NC STATE UNIVERSITY

Nuclear Reactor Program
Campus Box 7909
Raleigh, North Carolina 27695

Re: Technical Specifications Amendment
License No. R-120
Docket No. 50-297

Enclosures: Response to Request for Additional Information
R-120 License Change
Technical Specification Amendment 19
Attachment 1: Fueled Experiment Analysis

Example decay chain: $A = 133$

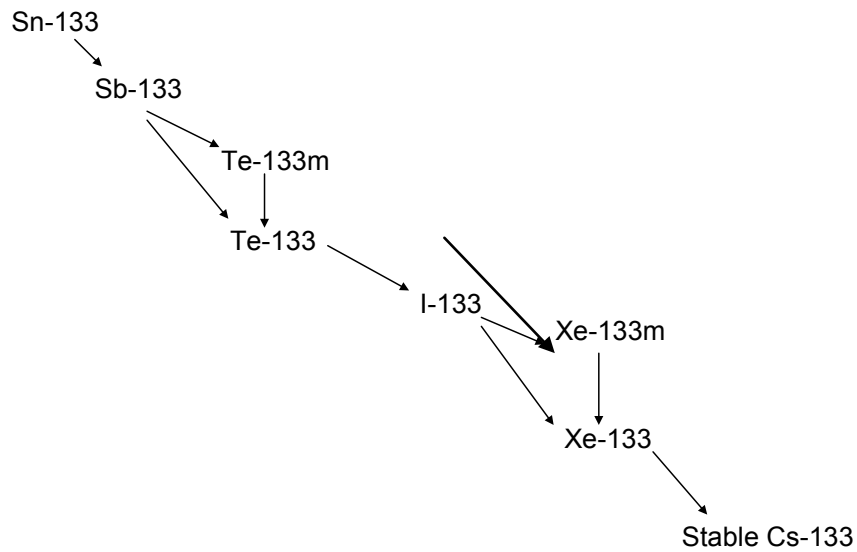
- a. The explanation of the number of atoms of Te-133 on page 30 does not match the results provided in the table on page 31. Provide the additional information, correction, or explanation for this apparent discrepancy.
- b. Provide an additional explanation for how the resulting atom populations are calculated.

- 12b The atom populations were calculated using the kinetic and decay equations given in Attachment 1. Atoms produced by redundant pathways are excluded. In the examples given, direct production of Te-133 calculated in the 5th pathway at 1.85E14 atoms is excluded a second time since this was included in the first pathway. Similarly, direct production of I-133 is only considered once in the first pathway and not in any others. A more detailed explanation of the example calculation was added in Attachment 1.

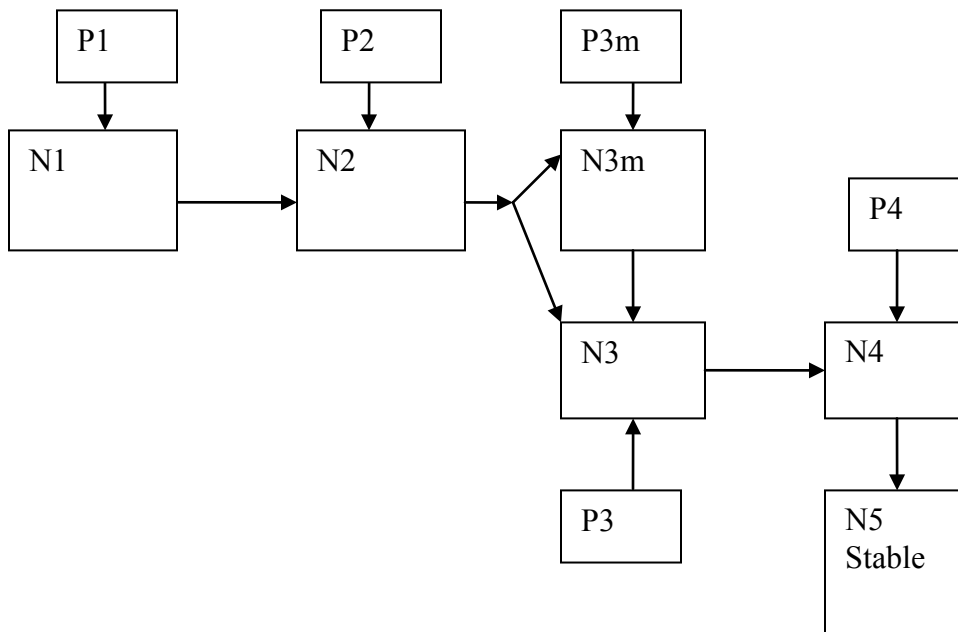
The “Source Term” section of Attachment 1 to the NCSU LAR provides equations for $N_3(t)$ and $N_4(t)$ (page 9 and page 10 respectively). Provide additional information regarding the solutions to the decay chain equations (e.g., $N_3(t)$ and $N_4(t)$). If taken from a reference, provide the reference.

Equations for $N_3(t)$ and $N_4(t)$ were given as examples of the solution for the equation for $N_n(t)$. In Attachment 1 Section B, the equation for $N_3(t)$ was removed since the equation for $N_4(t)$ adequately serves as an example to solution for $N_n(t)$. The equation for $N_4(t)$ was re-written with additional information provided to clarify which decay paths are included. It is noted that redundant paths are excluded to avoid accounting for the same pathway more than once.
